DESIGN	QD	DRAWN BY	DART AEROSPACE LTD
CHECKED	PH	APPROVED	HAWKESBURY, ONTARIO, CANADA
DATE	06.10.31	TITLE	REV. C
		BAR	1:4
A	03.06.25	NEW ISSUE	
B	06.09.25	ADD D3196-5	
C	06.10.31	ADD SLOTS ON -1; REMOVED -5

DRAWING NO. D3196	TITLE BAR	REV. C	DART AEROSPACE LTD ENGINEERING ORDER		D.E.O. NO. D3196-C-1	SHEET NO. SHEET 1 OF 2	SCALE NTS
DRAWN AJS	CHECKED	MFG. APPR.	APPROVED		DE APPR.		
DATE 08.08.27	DATE 08.08.28	DATE 08.08.29	DATE 08.08.29		DATE 08.09.04

DART AEROSPACE LTD		Work Order:	119374
Description: Bar		Part Number:	D3196-4
Inspection Dwg: D3196 Rev: C		Page 1 of 1

SHEET 1 MODIFY SLOT DIMENSIONING ON D3196-1 AS SHOWN:

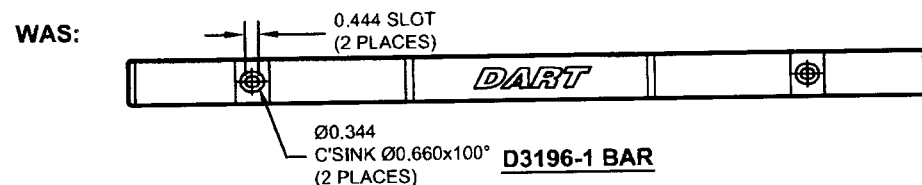
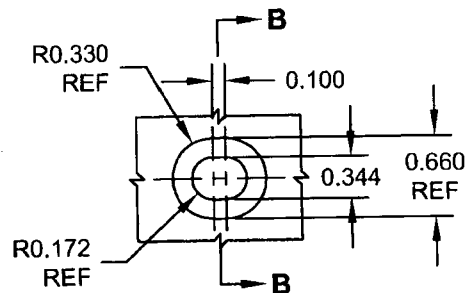
NOTE: THIS CHANGE HAS BEEN DONE TO CLARIFY SLOT DIMENSIONS ONLY. NO CHANGES HAVE BEEN MADE TO THE PARTS
SEE NCR 08-051 FOR FURTHER INFORMATION
ALL OTHER INFORMATION REMAINS UNCHANGED
